SUBJ: Cedar Hill Road Subdivision (1512-1524 Cedar Hill)-#25-07SUBD

Reference: 1512 & 1524 Cedar Hill Road Subdivision
TMP's #39-00-00646-00-8 and #39-00-00649-00-5
Preliminary/Final Land Development Application

Pursuant to your request, Gilmore & Associates, Inc. performed a review of the preliminary submission for land development for the above-referenced project. Upon review, we offer the following comments for consideration by the Lower Gwynedd Township Board of Supervisors:

PLAN SCALE	DRAFTED BY	PROJECT MANAGER	PLAN SHEET NUMBER
HORIZONTAL:	M.J.P.	S.A.R.	
VERTICAL:	PROJECT NUMBER	DRAWING FILE NUMBER	
1" = 30'	6571	6571PDRV	15 OF 18

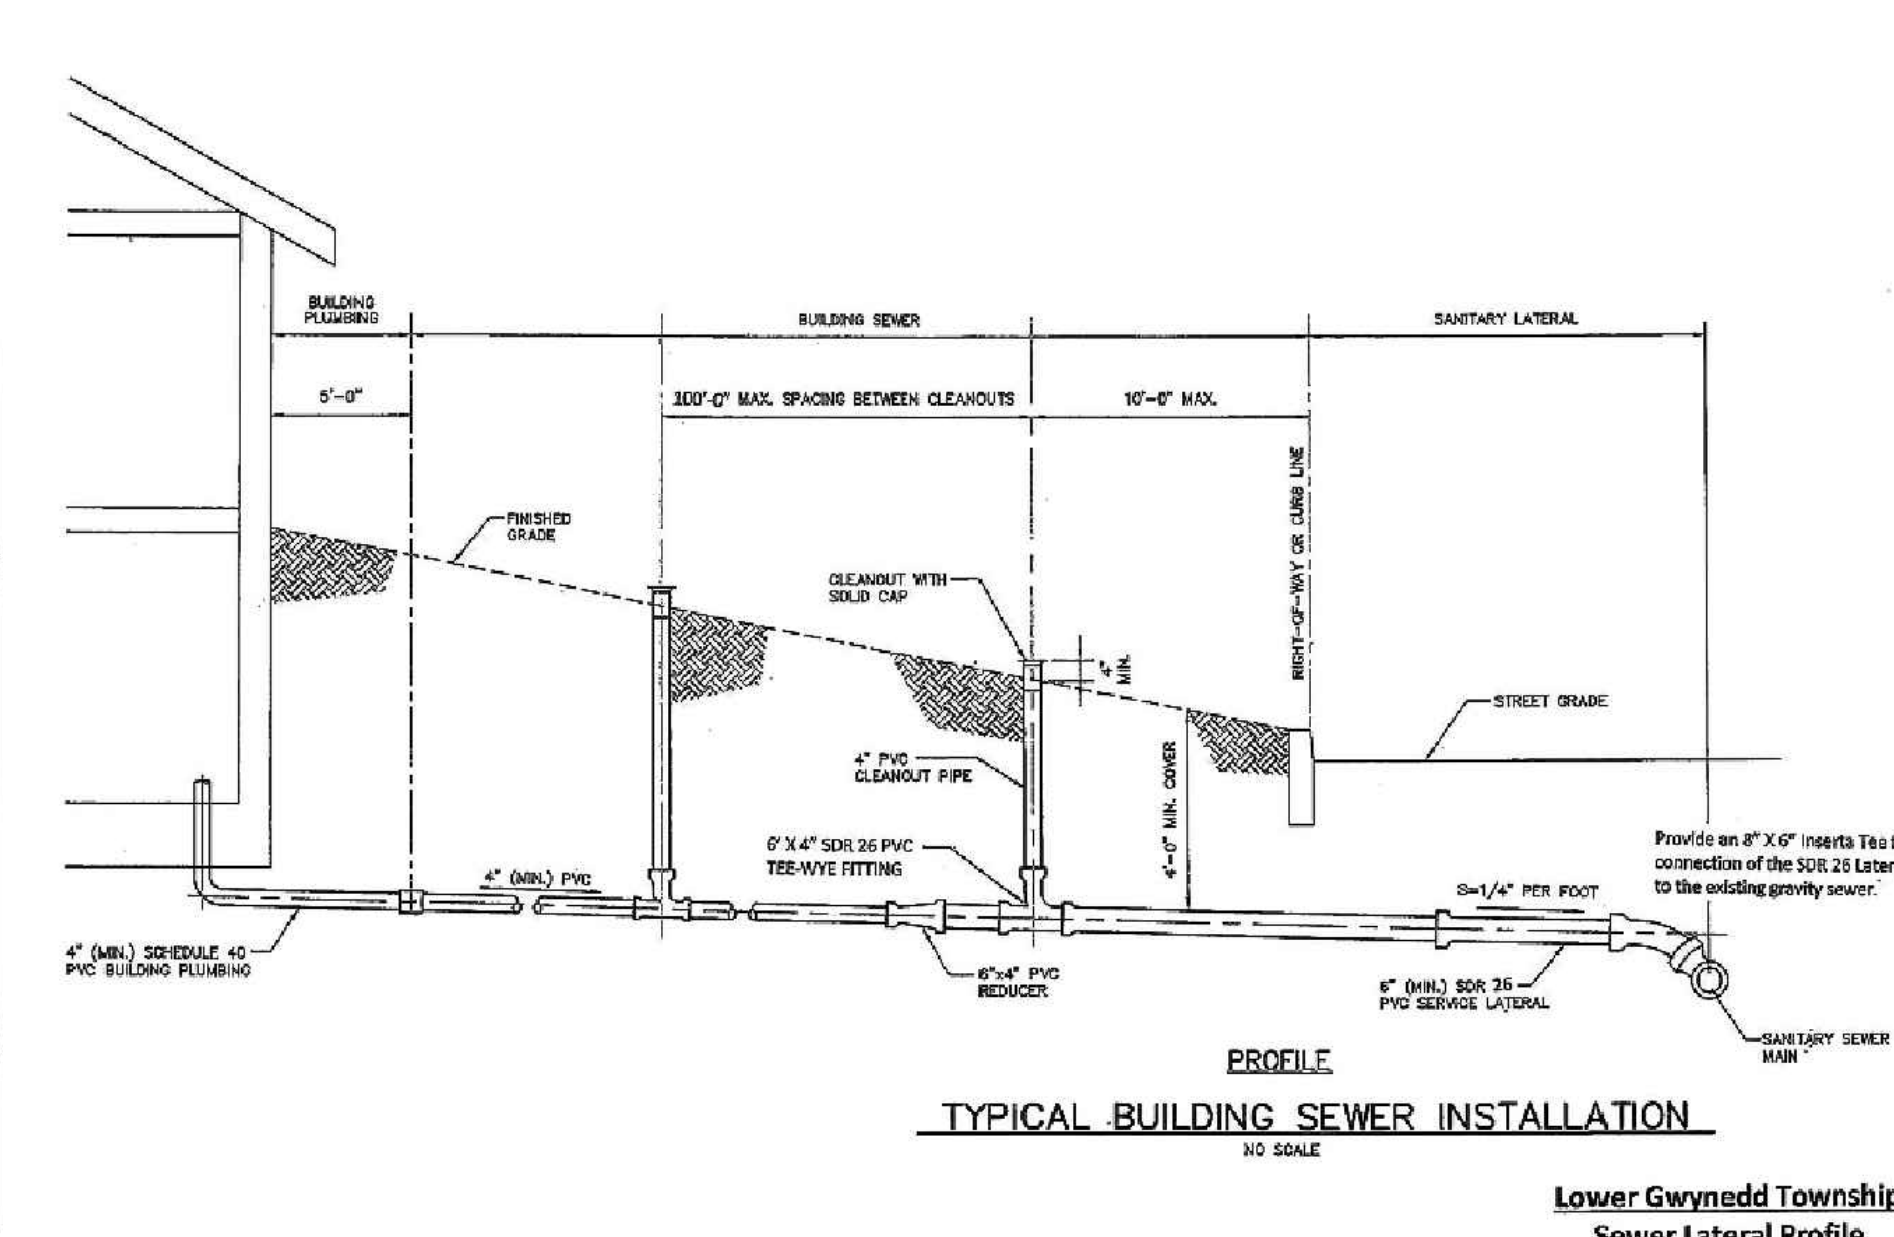
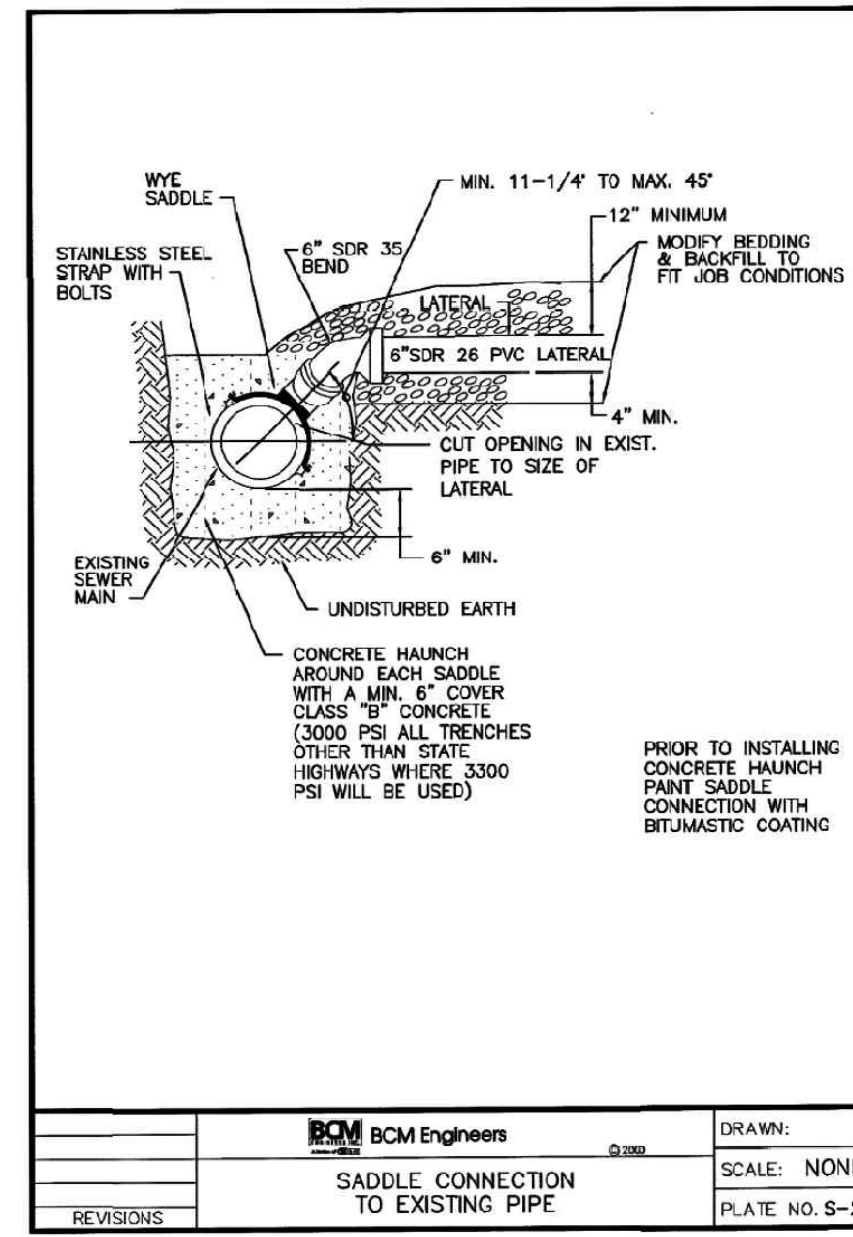
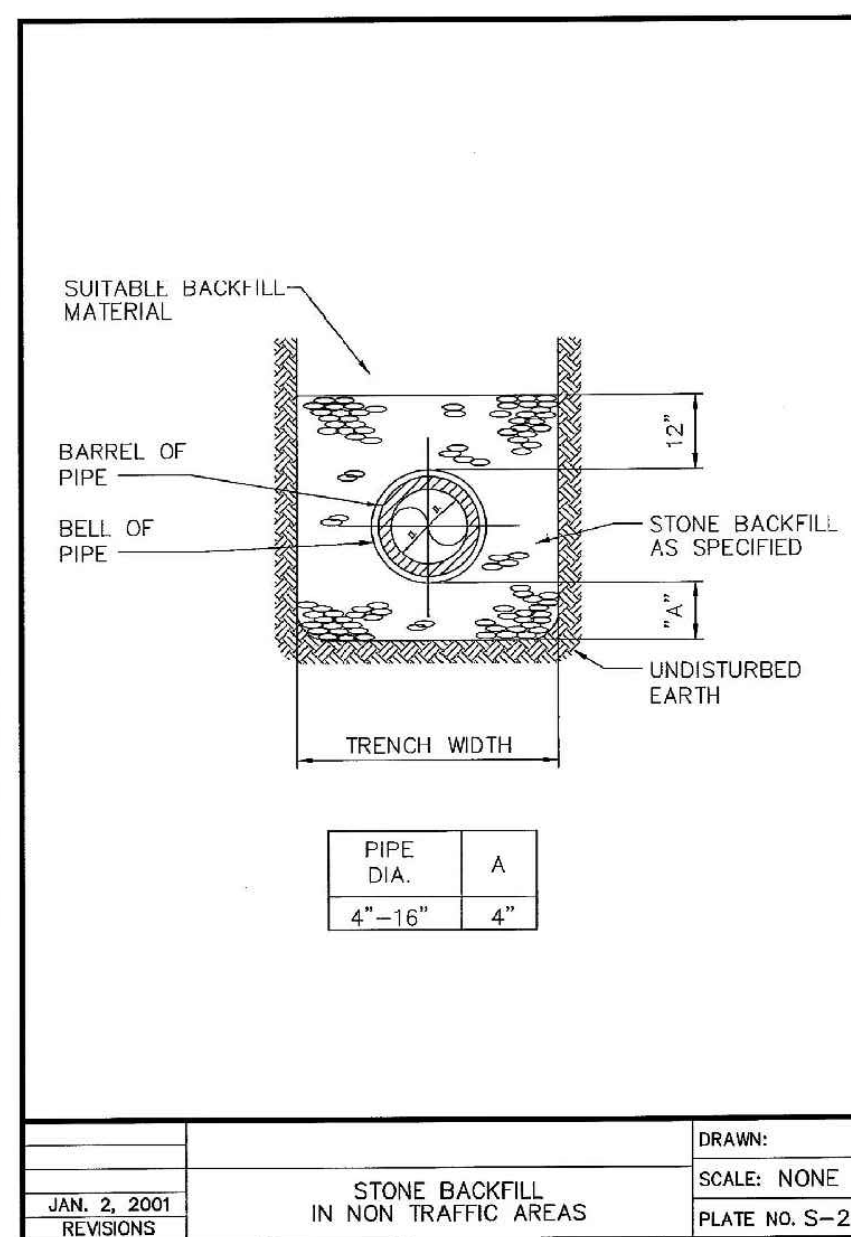
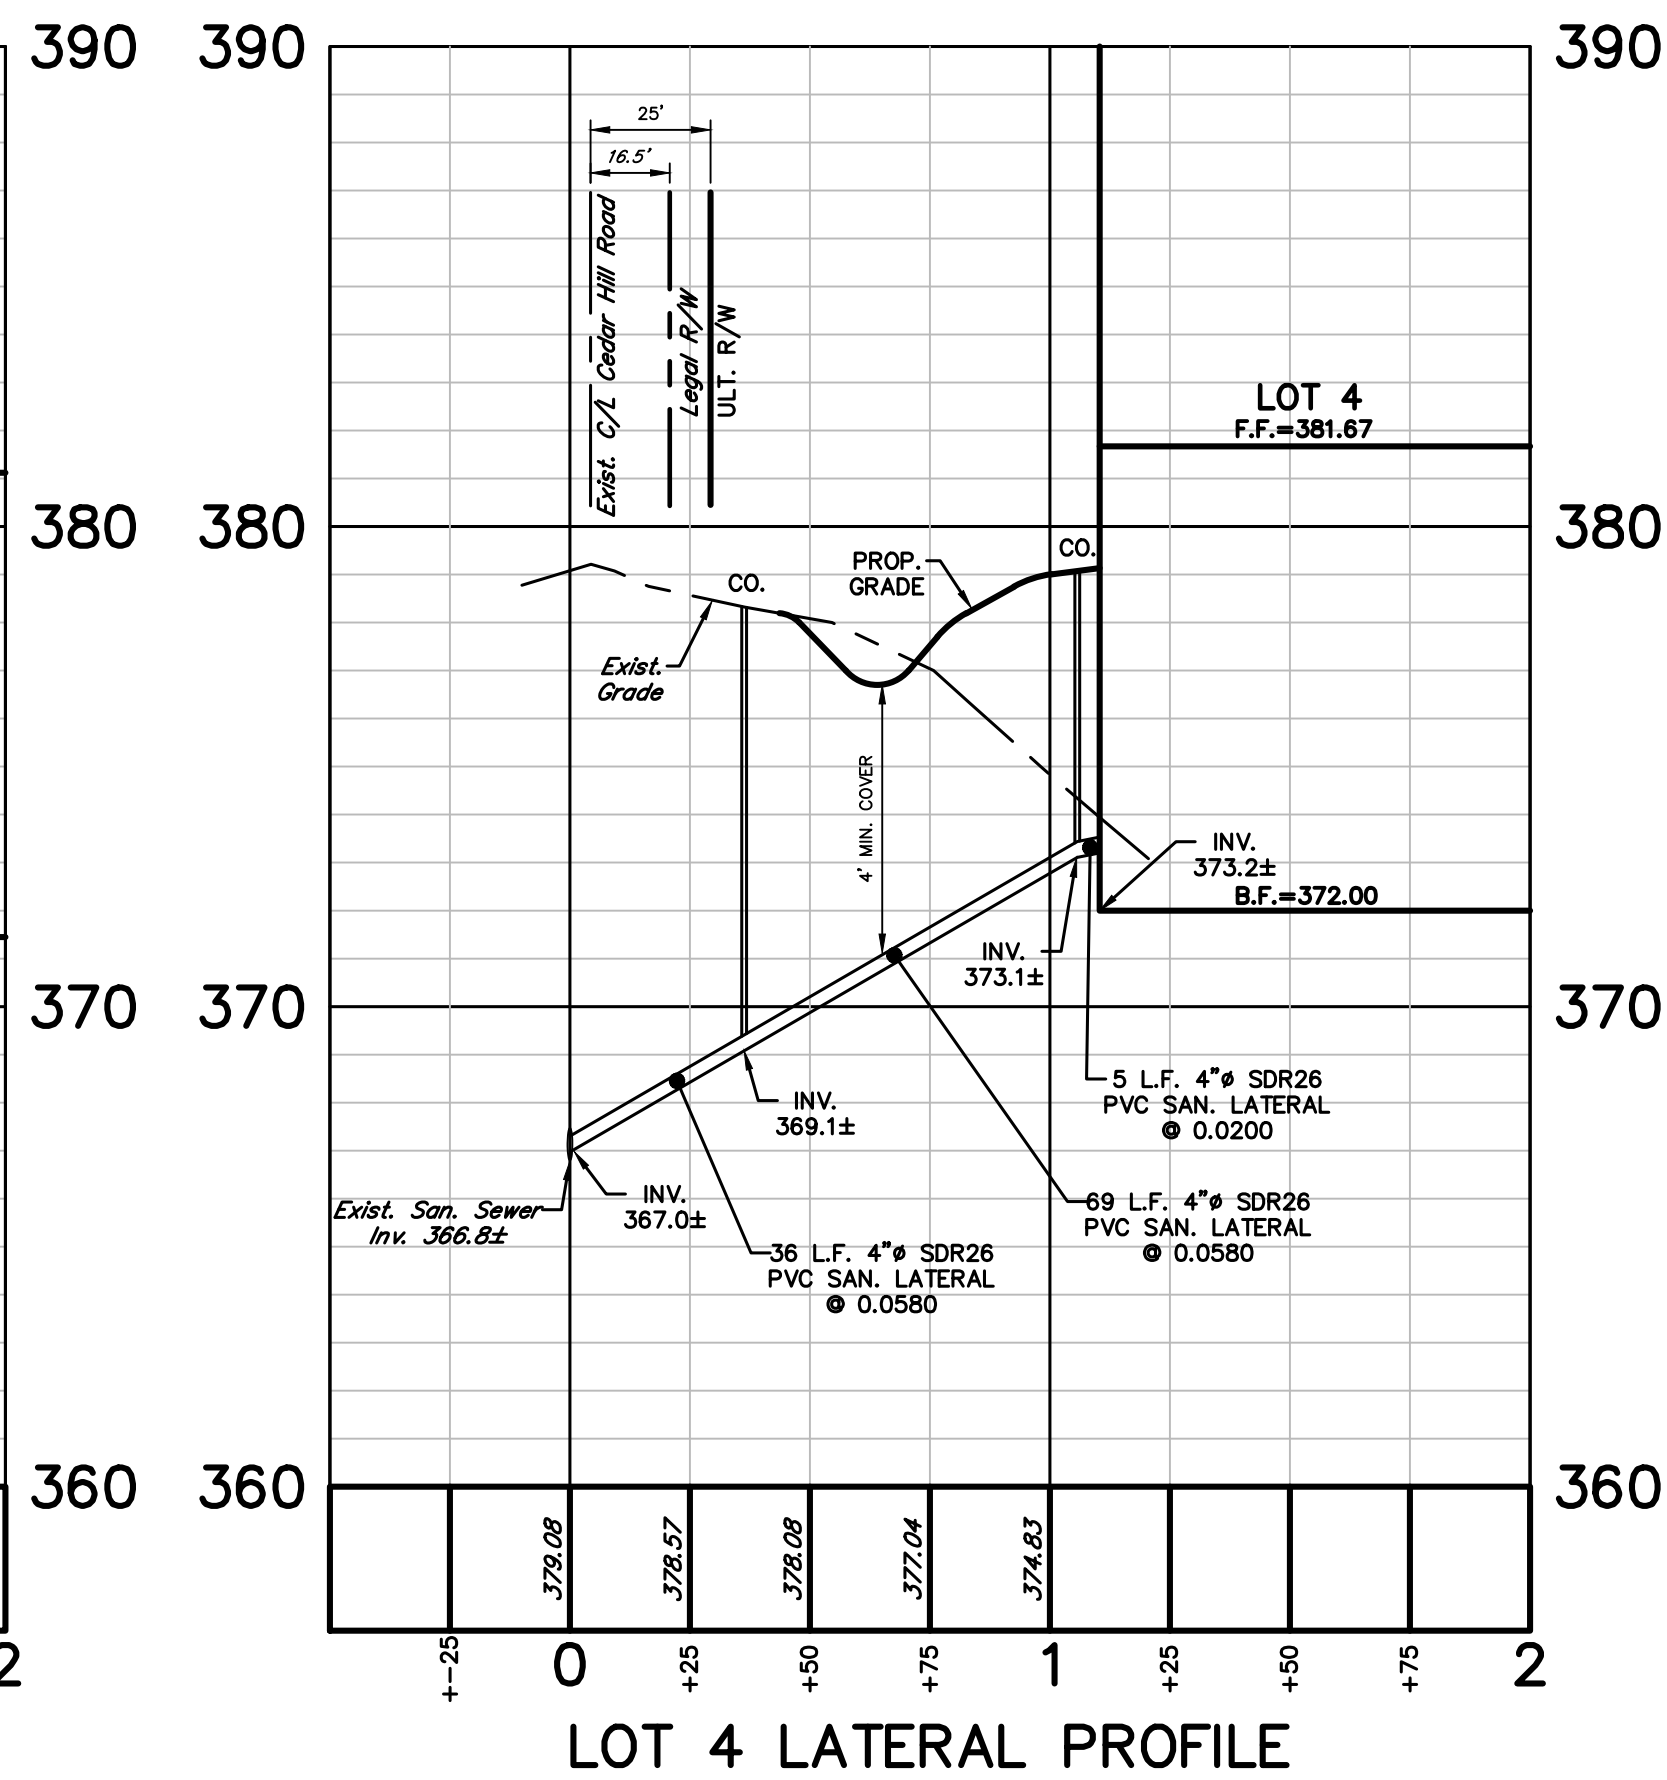
3. Additional details for the proposed driveways to lots 1 to 4 must be added to the plans. The driveways must be designed in accordance with **Section 1230.38** of the **Subdivision and Land Development Ordinance** with respect to grades and widths. The details should include the following:
 - a. Driveway tie-in radii.
 - b. Driveway width(s).
 - c. Driveway grades, as well as the cross-slope grades of the roadway.
 - d. Location and distance of driveway grade breaks.

Response: The requested information is provided on Sheet 15.
